Re: Fuel Leak Case No: RO0000133

Enclosed please find a request for a modification to the Additional Site Investigation Work Plan Addendum for the former City of Paris Cleaners site located at 3516 Adeline Street, Oakland, CA 94608 and dated January 7, 2011. This request was prepared by Taber Consultants of West Sacramento, California.

**Re: City of Paris RO#0000133,  
Revisions to Additional Site Investigation Work Plan  
Taber Project No. 051074**

Attachment: Figure 1. Proposed Soil Boring/Contingent Soil Borings

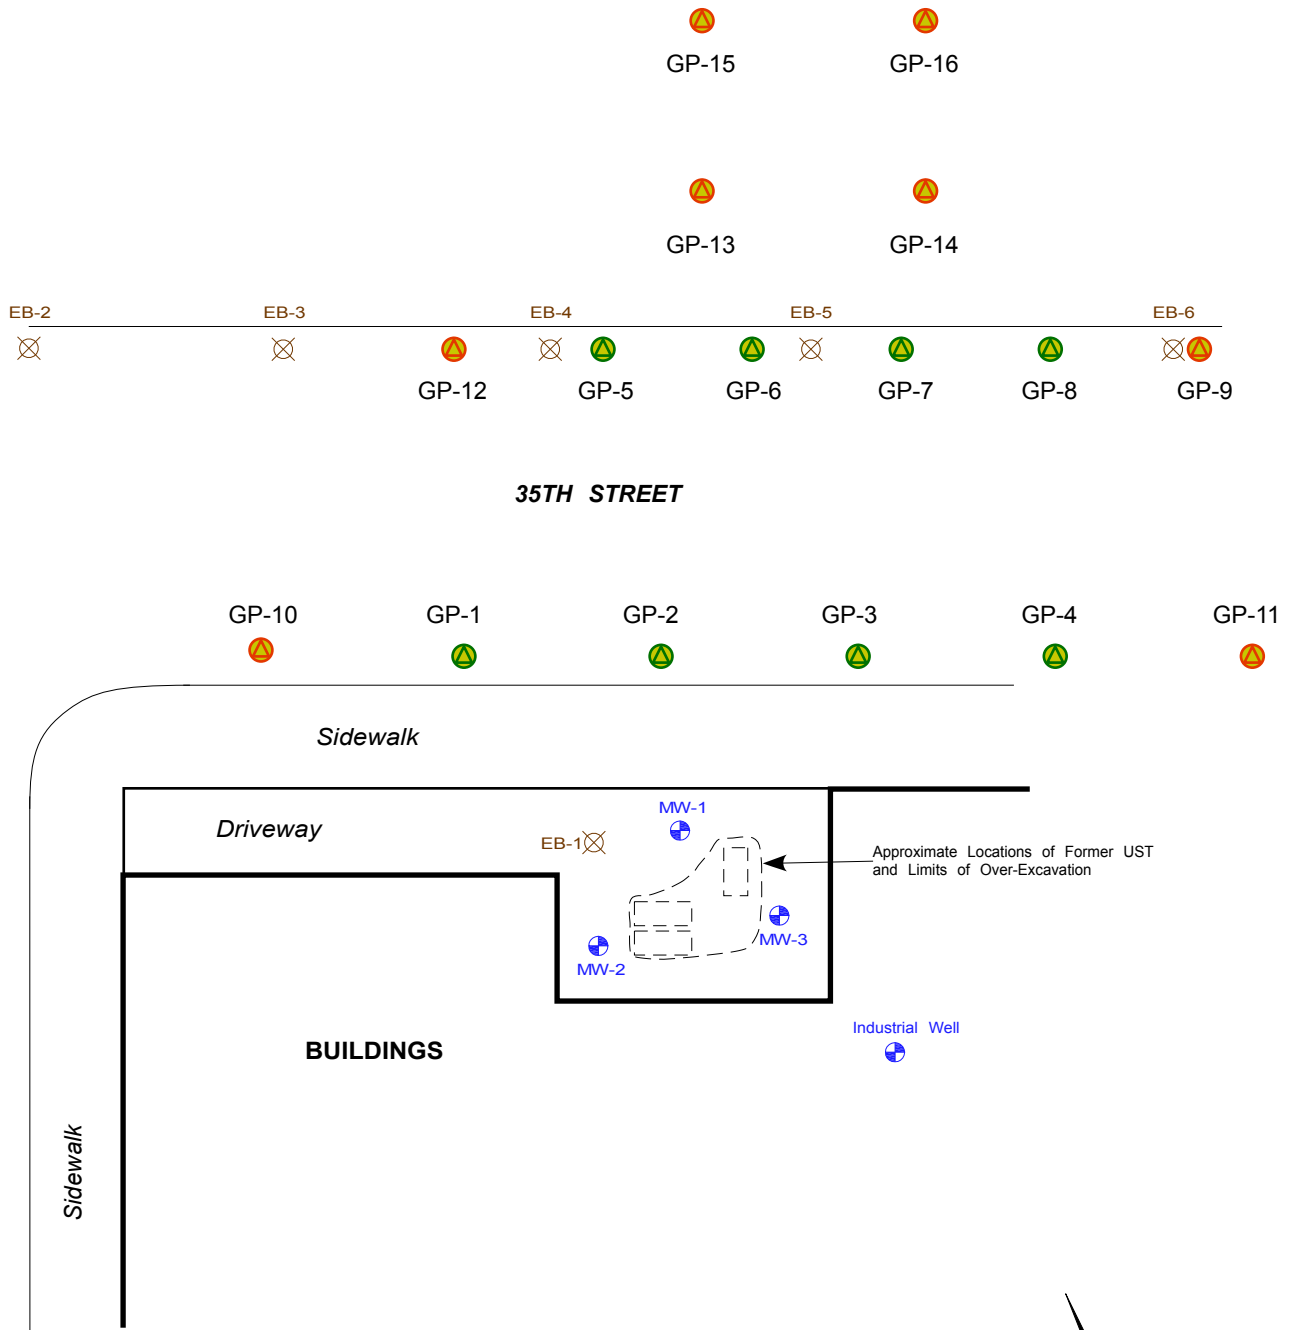
Taber Consultants intends to advance between 8 and 16 soil borings. To delineate the lateral distribution of the Stoddard Solvent (TPH-SS) plume, Taber Consultants will take both soil samples and grab groundwater samples from the borings. In 1998, the grab groundwater sample from soil boring EB-5 had a TPH-SS concentration of 760 ug/l. Taber Consultants intends to advance borings to the east and west of the approximate location of EB-5 to attempt to determine the plume boundaries to the north of the site. Taber Consultants may also want to advance soil borings to the north of 35th Street if analysis of samples indicates the TPH-SS plume has extended to below the freeway. Taber Consultants is contacting CalTrans in order to evaluate their encroachment permit requirements to determine the feasibility of stepping out the site investigation. Please see the attached Figure 1 for boring locations.
